# DOCUMENT CHANGE REQUEST

DCR number	265	Changes required for:	General	Originator:	Ron Fidler
Date:	2006/07/24	Date sent:	2006/07/24	Organisation:	ESA/ESTEC
Status:	IMPLEMENTED

Title: Transistors Low Power NPN, based on type 2N2219A

Number:	5201/003	Issue:	1
---------	----------	--------	---

**VOLTAGE WAVEFORMS**

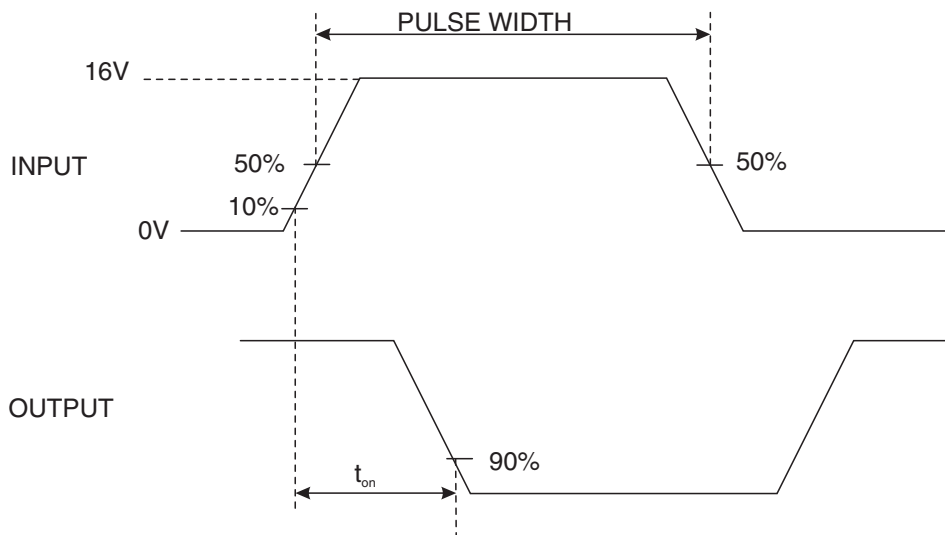
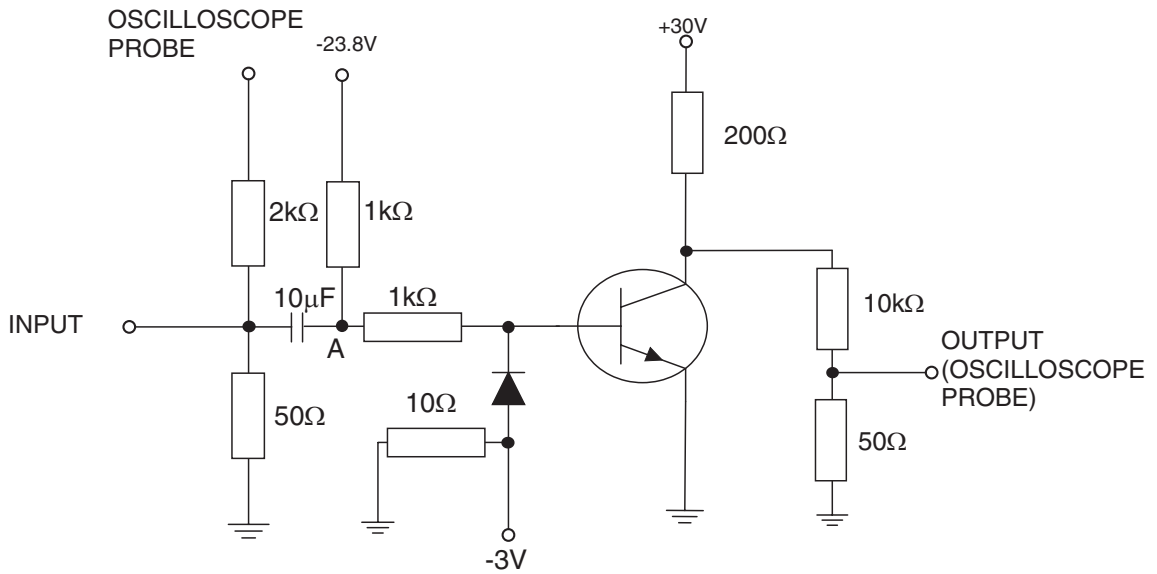
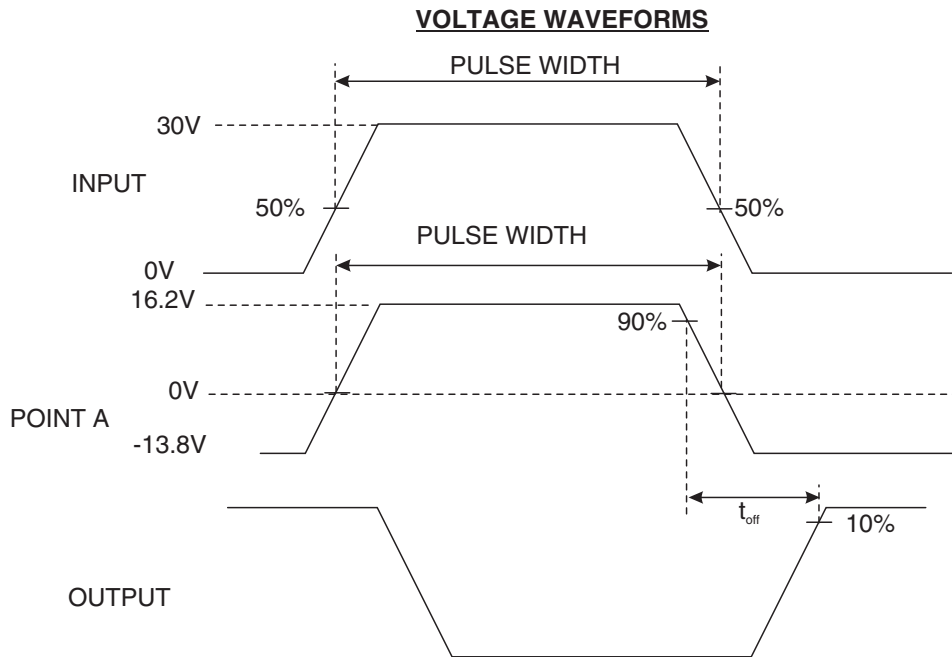
13. Table 2 and Figure 4 - MIL test method deleted from tON and tOFF and new Notes 3 and 4 added which fully define the tests based upon the actual test circuits and conditions used by STM and show the test circuit and the waveforms. For the tOFF the test condition for the Base Current was corrected.

1. Pulse measurement: Pulse Width  $\leq 300\mu\text{s}$ , Duty Cycle  $\leq 2\%$
2. For AC characteristics read and record measurements shall be performed on a sample of 32 components with 0 failures allowed. Alternatively a 100% inspection may be performed.
3.  $t_{\text{on}}$  shall be measured using the following test circuit. The input waveform shall be supplied by a pulse generator with the following characteristics:  $Z_{\text{OUT}} = 50\Omega$ ,  $t_r \leq 2\text{ns}$ , Pulse Width =  $200 \pm 10\text{ns}$ , Duty Cycle  $\leq 2\%$ . The output waveform shall be monitored on an oscilloscope with the following characteristics:  $Z_{\text{IN}} \geq 100\text{k}\Omega$ , Input Capacitance  $\leq 12\text{pF}$ ,  $t_r \leq 5\text{ns}$ .

4.  $t_{\text{off}}$  shall be measured using the following test circuit. The input waveform shall be supplied by a pulse generator with the following characteristics:  $Z_{\text{OUT}} = 50\Omega$ ,  $t_r \leq 2\text{ns}$ , Pulse Width =  $10\mu\text{s}$ , Duty Cycle  $\leq 2\%$ . The output waveform shall be monitored on an oscilloscope with the following characteristics:  $Z_{\text{IN}} \geq 100\text{k}\Omega$ , Input Capacitance  $\leq 12\text{pF}$ ,  $t_r \leq 5\text{ns}$ .
